City of Portland Design Commission

Design Advice Request

SUMMARY MEMO

Date: September 11, 2023
To: Kurtz Schultz | SERA Design and Architecture
From: Tanya Paglia, Design & Historic Review Team
503-865-6518 | Tanya.Paglia@portandoregon.gov
Re: EA 23-050424 DA – Con-way Block 292 East
Design Advice Request Commission Summary Memo – August 17, 2023 Meeting

HEIGHT MODIFICATION REQUESTED

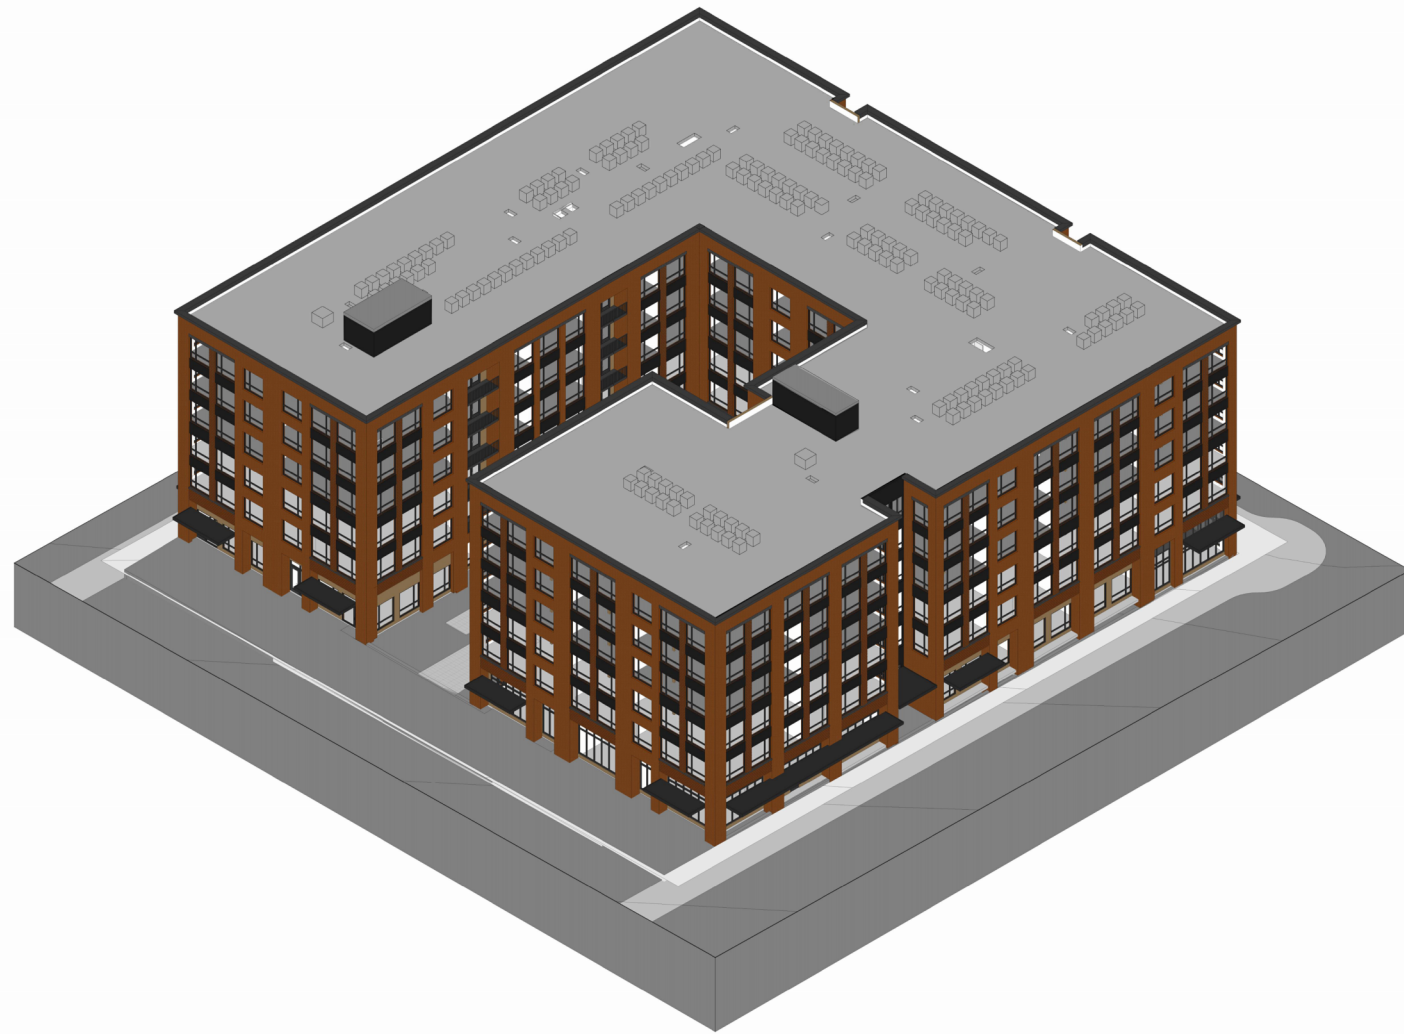
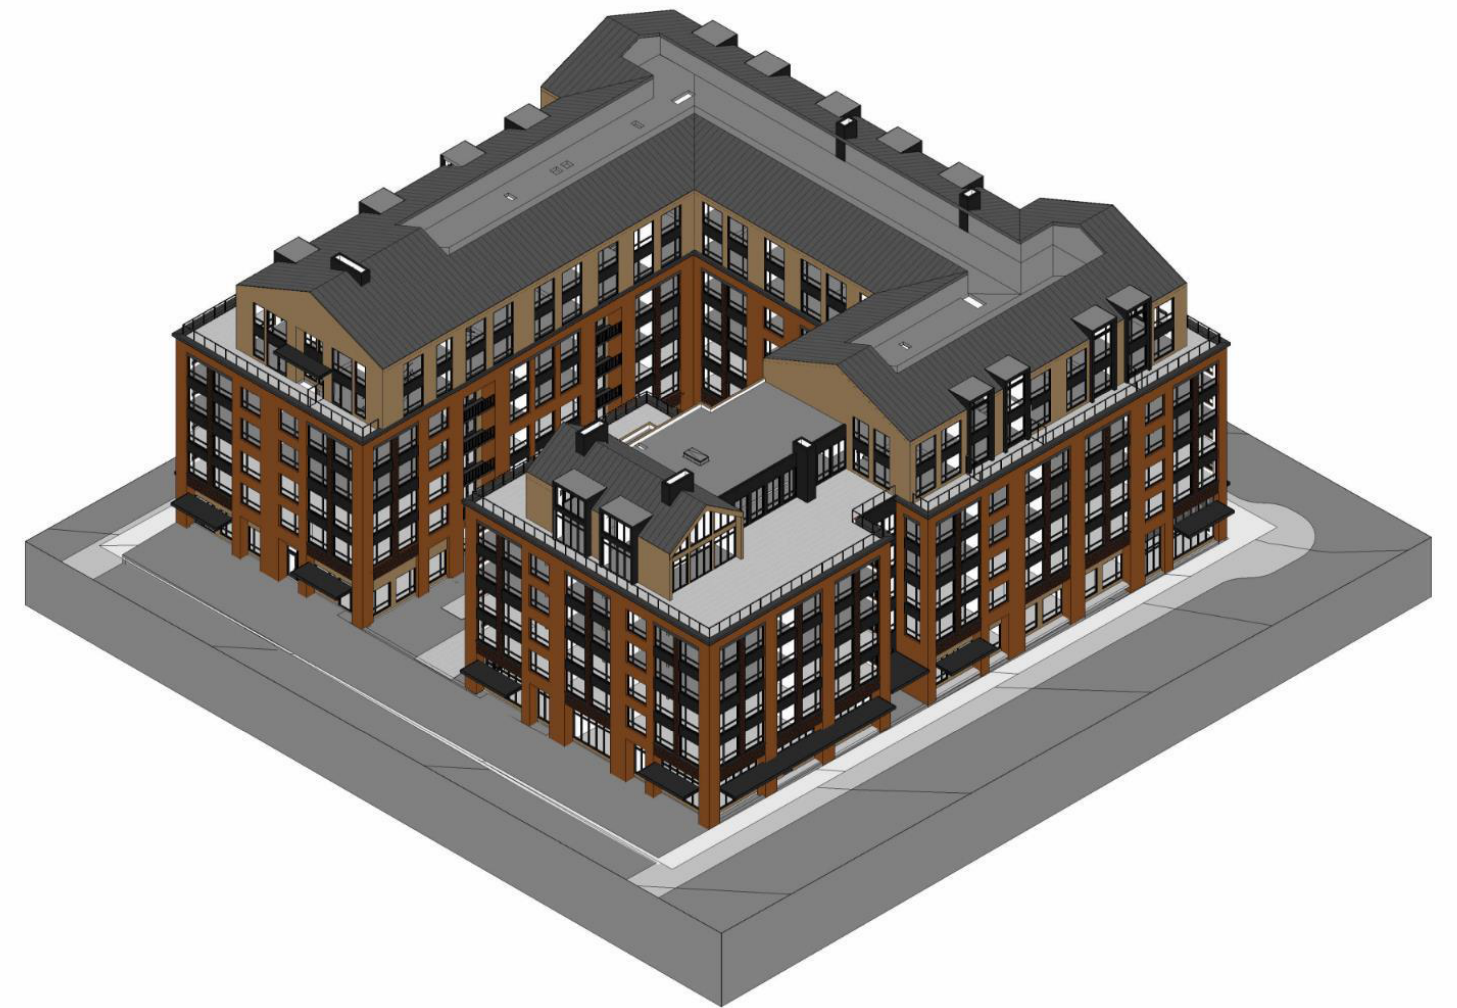
- The majority of commissioners present could potentially support the large height Modification depending on the evolution of the design, with focus on significantly giving back to the public realm and dialing in the architecture.

- **Modification to Building Height and Penthouse Roof Form.**
 - Majority of commissioners present could potentially support the large height Modification depending on the evolution of the design. All potential supporters concurred that the building would need to significantly give back more to the public realm in order to justify the additional height with particular attention to the public realm at the ground floor. Potential ground floor improvements include:
 - More active use at the ground floor frontages.
 - Art and water features.
 - Better layering of the ground floor units with stoops, landscape setback, screening and/ or convertible ground floor space.

- Support for the Modification would also be boosted by further development of the townhouse design – maintain deep setbacks as shown and simplify the design. Potentially reduce the overall height [roof slope].

- For some, the added skyline variety in the district was an extremely compelling reason for the Modification. The monotony of the 6-story datum line across the district was noted. The gables would add architectural variety, and their forms would break up the height and massing of the building.

- Several commissioners noted that while it added interest, the design of the penthouse still needed some work. The proportions were noted as strange in the wider gabled forms causing a visual foreshortening the building.

- Concerns were expressed that the penthouse was extremely complex while the base was extremely stoic. Commission recommended that studies should be done, included as a part of the initial Land Use submittal, to see if the penthouse and base could be brought into better balance with a simplified design and/or detail added to the building base. Color studies were also requested to understand if more color contrast would work better.
